**From:** James Cox  
**Sent:** 02 April 2019 08:51  
**To:** Rob Smith  
**Subject:** RE: Woodsmith Mine - NYM/2019/0129/NM [NLP-DMS.FID262297]

Further to your email below, please find attached final revised drawings to reflect a RAL 7016 finish on the roof.

Project: **653 York Potash**  
 Drawing Title: Mining Buildings Elevation Study - Colour  
 Scale: 1 : 50 @ A1  
 Drwg. Created: June 2014

DRAWING TITLE: Production Shaft Setting Out Elevations

**DRAWING TITLE:** Service Shaft Setting Out Elevations

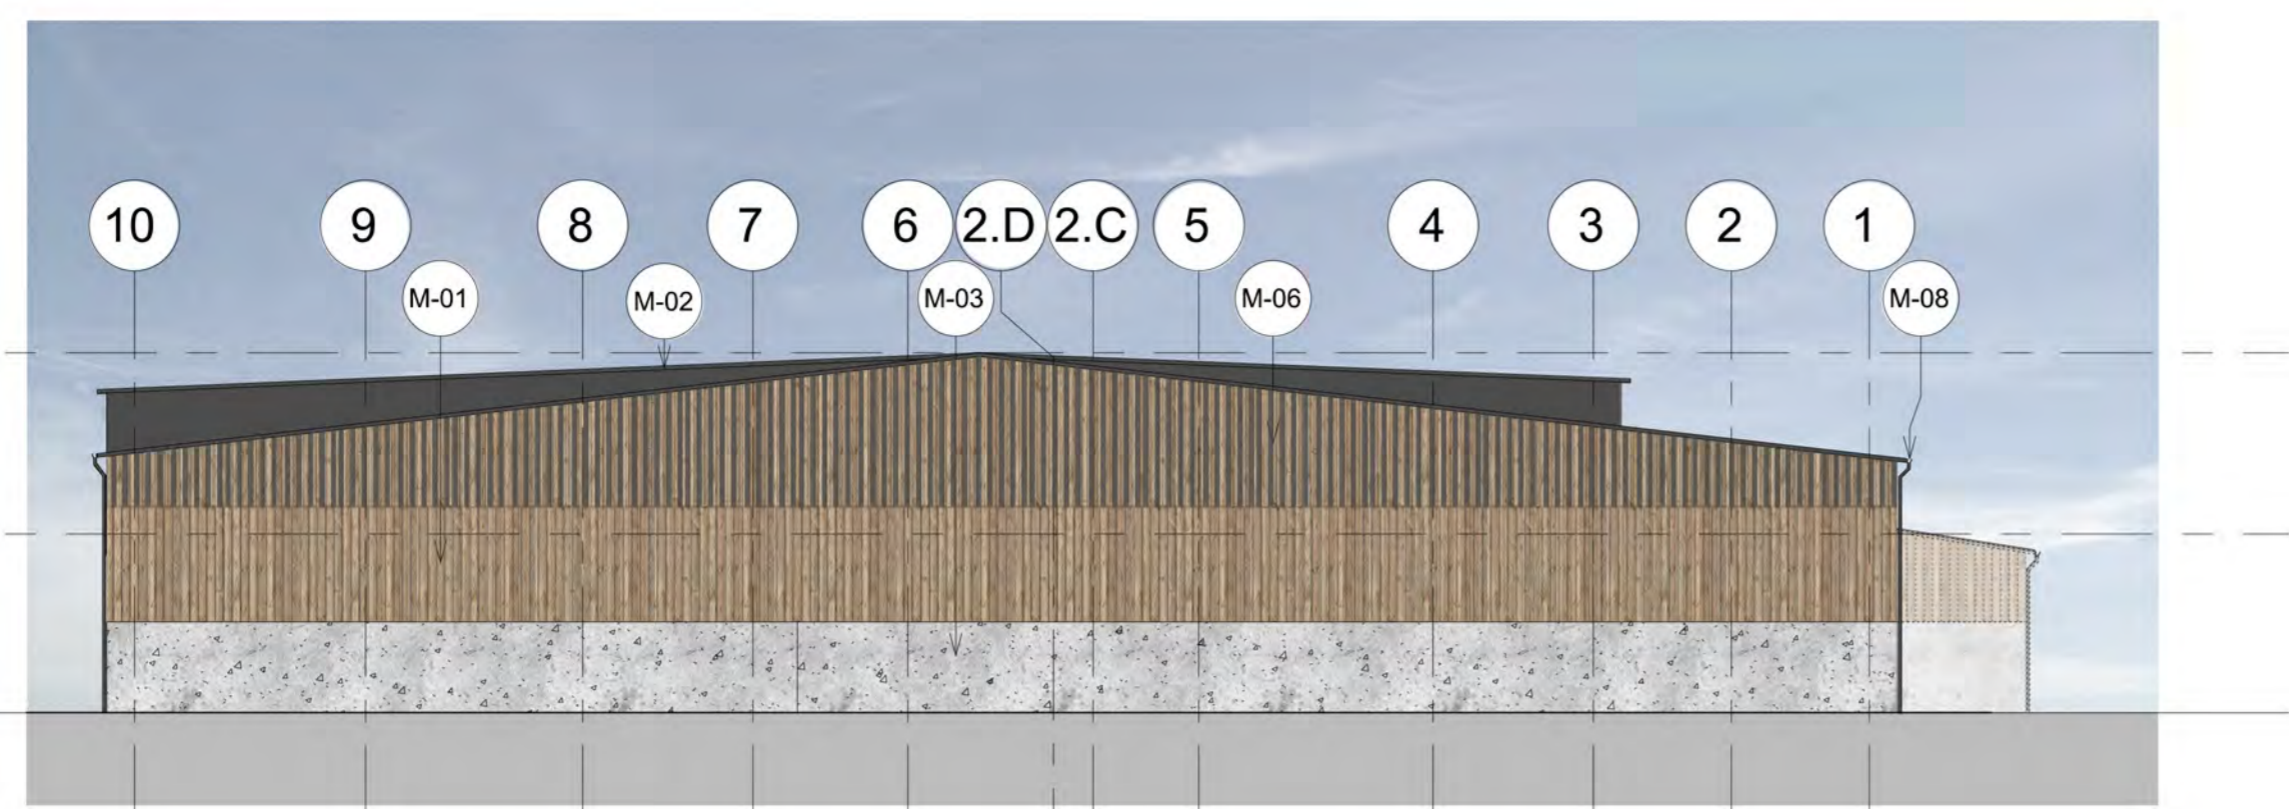
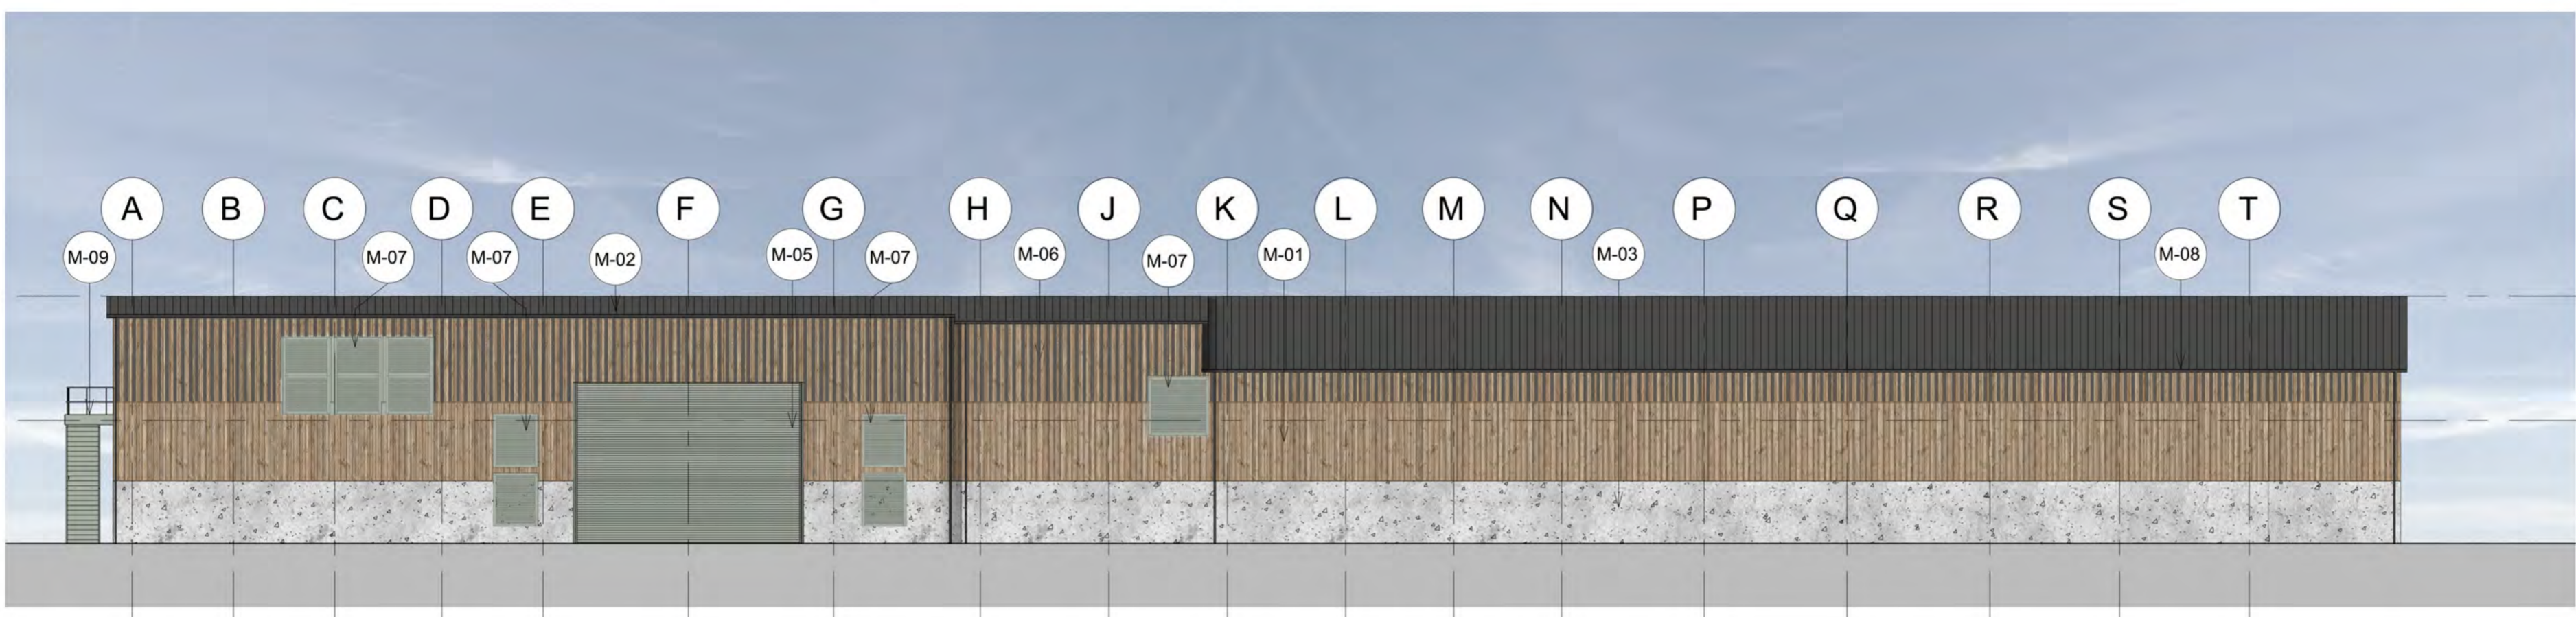
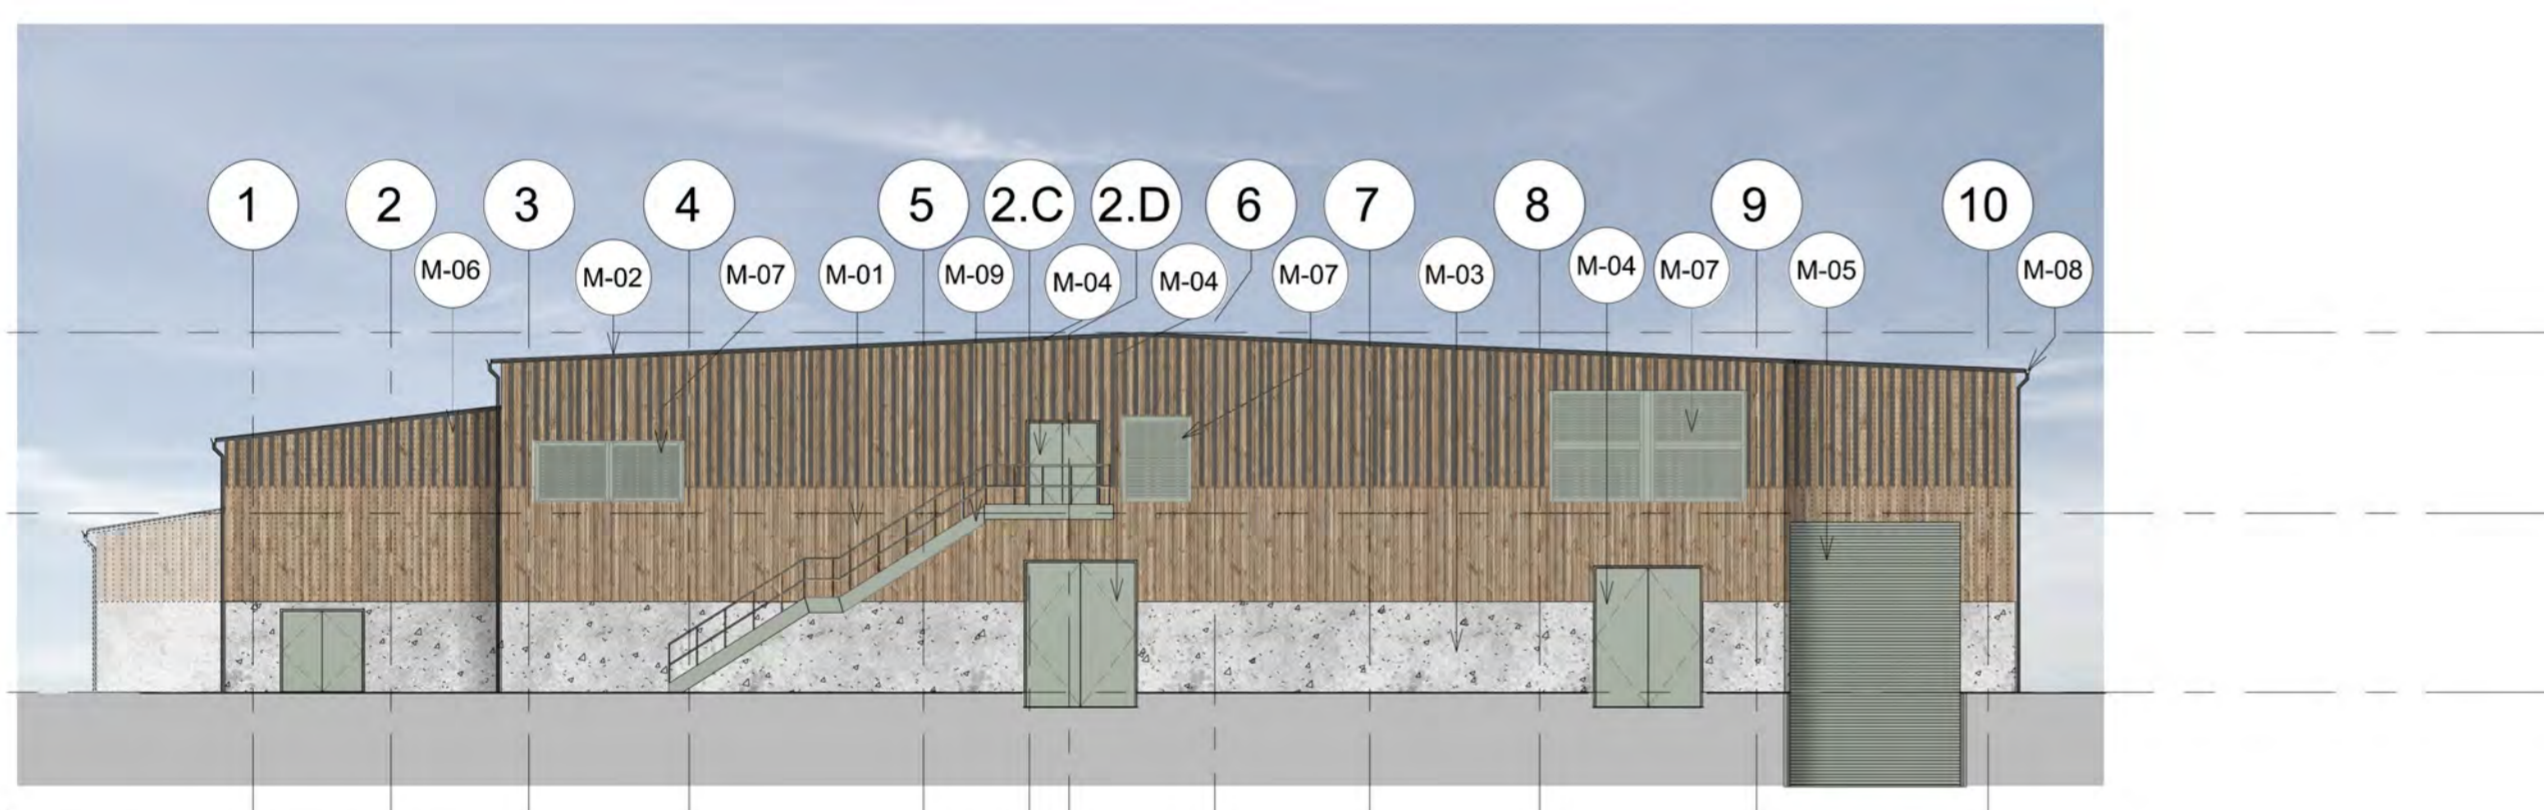
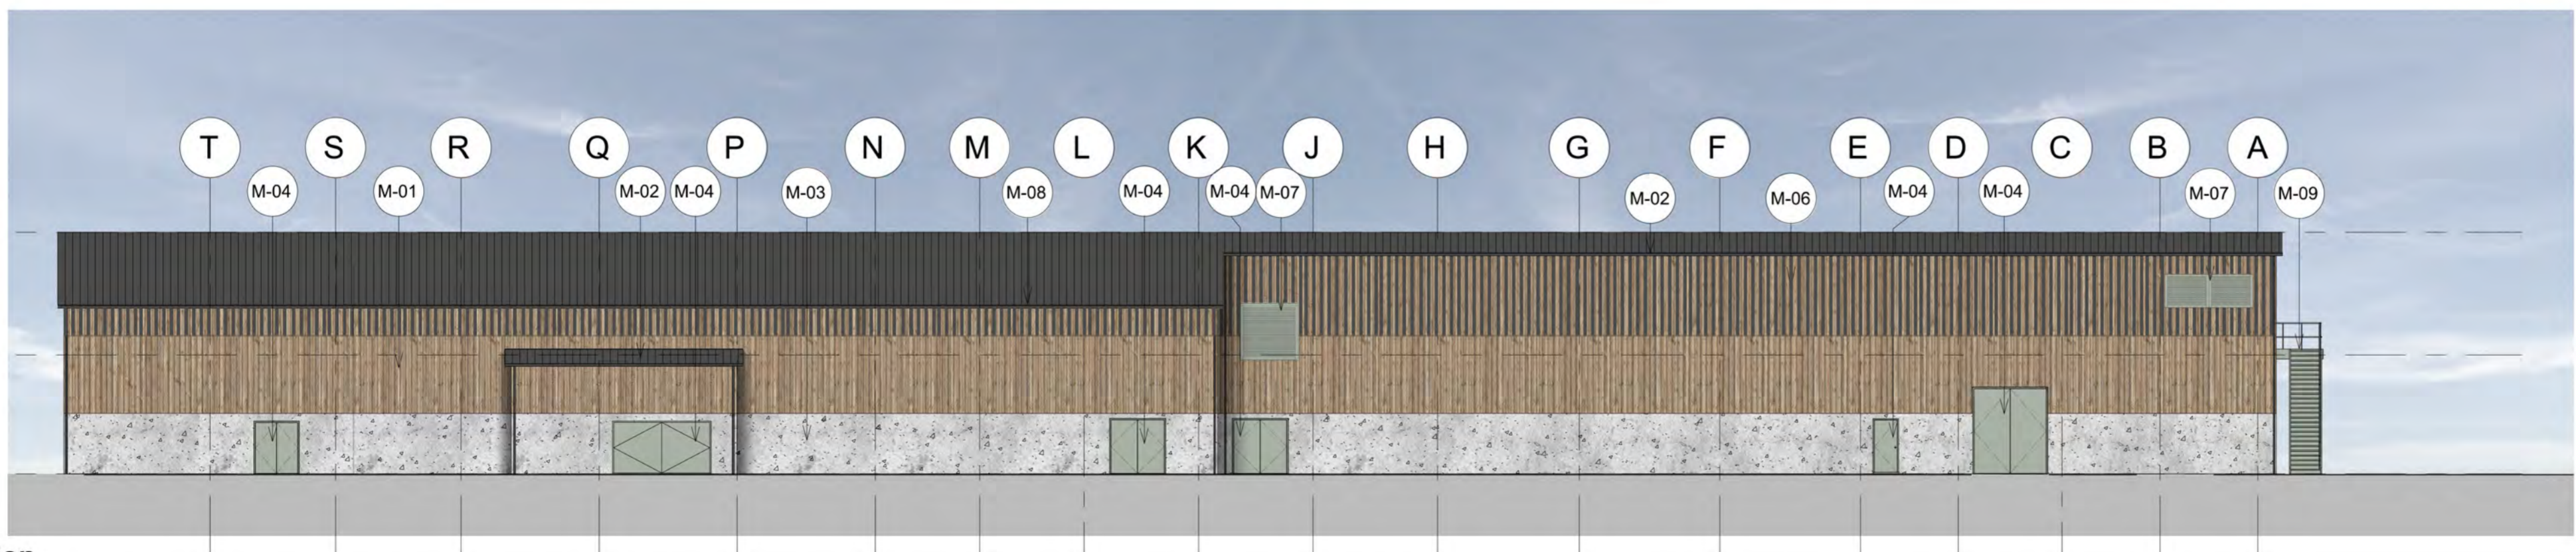
REVISION	DESCRIPTION	DATE	BY	CHKD	APPD
P	ROOF RAL COLOUR UPDATED	04/01/19	AK	JS	IW
N	RAL COLOUR UPDATED	25/03/19	AK	JS	IW
M	CLADDING INTERSECTION LOCATION UPDATED	15/03/19	AK	JS	IW
L	RAL COLOURS UPDATED	11/03/19	AK	JS	IW
K	RAL COLOUR AMENDED	05/03/19	AK	JS	IW
J	UPDATED FURTHER TO COMMENTS	20/02/19	AK	JS	IW
H	UPDATED FURTHER TO COMMENTS	20/02/19	AK	JS	IW
G	UPDATED FURTHER TO COMMENTS	19/02/19	AK	JS	IW
F	UPDATED FURTHER TO COMMENTS	18/02/19	AK	JS	IW
